Response to Maple Lodge RFI 27th January 2023

10 February 2023 Date: Jacobs U.K. Limited Project name: Thames Water STC IED 1180 Eskdale Road Winnersh, Wokingham

Project no: B22849AZ

Attention: Sarah Raymond, Environment Agency

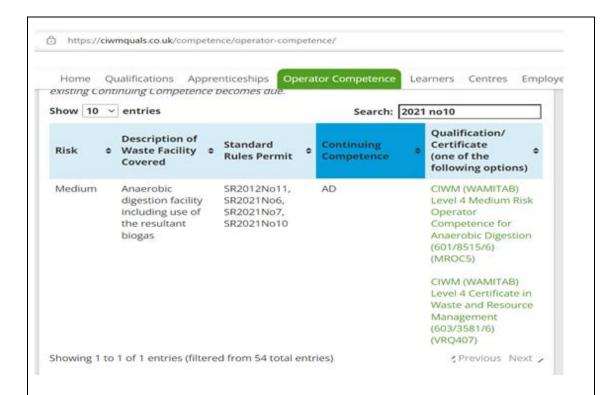
- a) Your ability as an operator. You have provided 'Appendix B COTC', which provides your initial registration for "CIWM (WAMITAB) Level 4 Certificate In waste and Resource Management VRQ" and optional "VRQ407 Principles and practices of managing a biological treatment processing facility (Anaerobic Digestion and Composting)" subject to the provision of relevant forms. The activity that you have applied for requires CIWM (WAMITAB) Level 4 Medium Risk Operator Competence for Anaerobic Digestion (MROC5). As a minimum to progress your application, we require evidence of registration for an appropriate scheme, or evidence of how you will provide the relevant technical competence at permit issue.

2a) Following Thames Water's, original communications with the Environment Agency and CIWM (WAMITAB), Thames Water understands there are two routes to holding an appropriate CoTC for the permit as laid out in the screen shot below:

- a) CIWM (WAMITAB) Level 4 medium risk operator competence for anaerobic digestion (MROC5)
- b) CIWM (WAMITAB) Level 4 Certificate In waste and Resource Management VRQ" and optional "VRQ407 – Principles and practices of managing a biological treatment processing facility (Anaerobic Digestion and Composting)"

Thames Water intends to follow option B for TCM provision at Maple STC.
